Project Title: Refurbish Elevators and Replace Controls

Solicitation Questions and Answers
for
Refurbish Elevators and Replace Controls
Project: 437-22-101, RFP: 36C26324R0021
12/15/2024

Solicitation Questions and Answers (updated 3-26-2024) for
 Refurbish Elevators and Replace Controls
 Project: 437-22-101, RFP: 36C26324R0021

5 FLOOR PLAN - PATRIOT ELEVATOR 10 - PIT
1/4" = 1'-0"

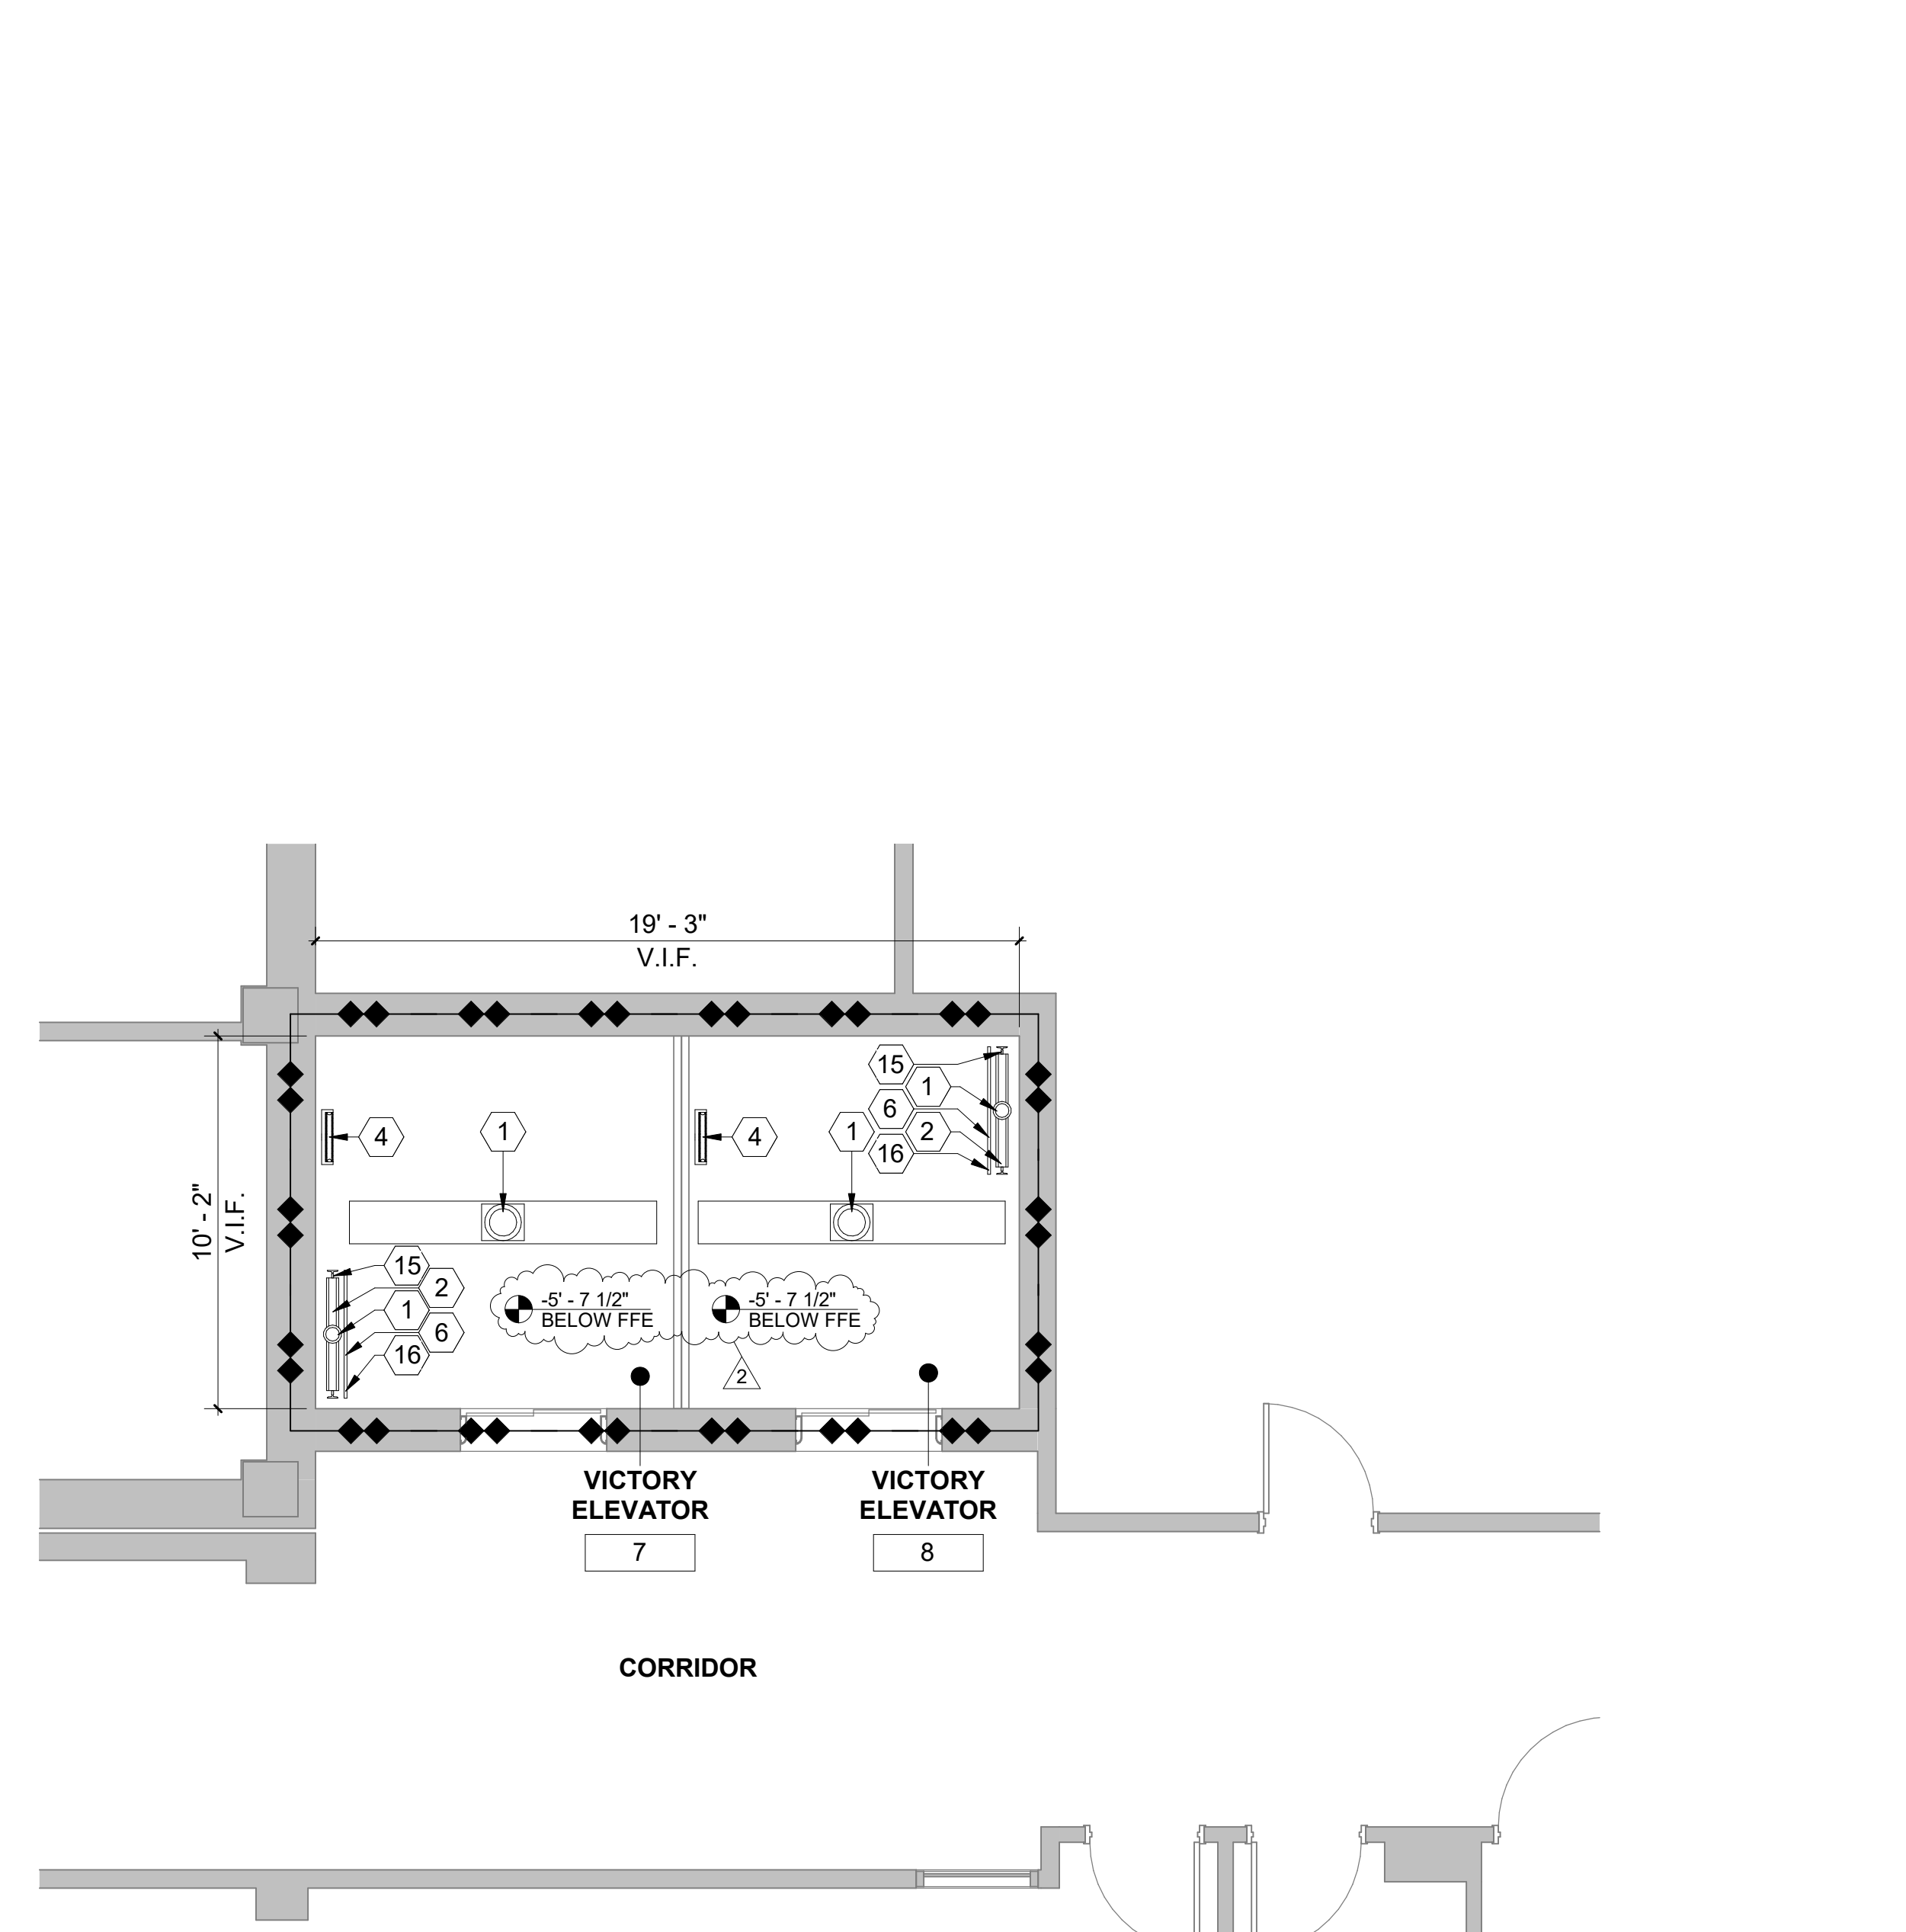
60.	2.17	2.17 - Elevator 10 does not need a casing since it is a twin post hydraulic elevator above ground. It is recommended that packing gets replaced in both jacks.	<i>Note 13/AD5.20 notes that the existing hydraulic piston is to be reused. Reuse existing hydraulic piston but replace packing in both jacks. See revised note 13/AD5.20 AND 17/A5.20.</i>

Drawing Sheet A5.20 ENLARGED PLANS – ELEVATOR PITS – See revised drawing sheet for the adjustment of keynotes # 3, 9, 15, 16, 17. Also included is the depth of each elevator pit relative to the floor elevation at the lowest elevator lobby for each hoistway.
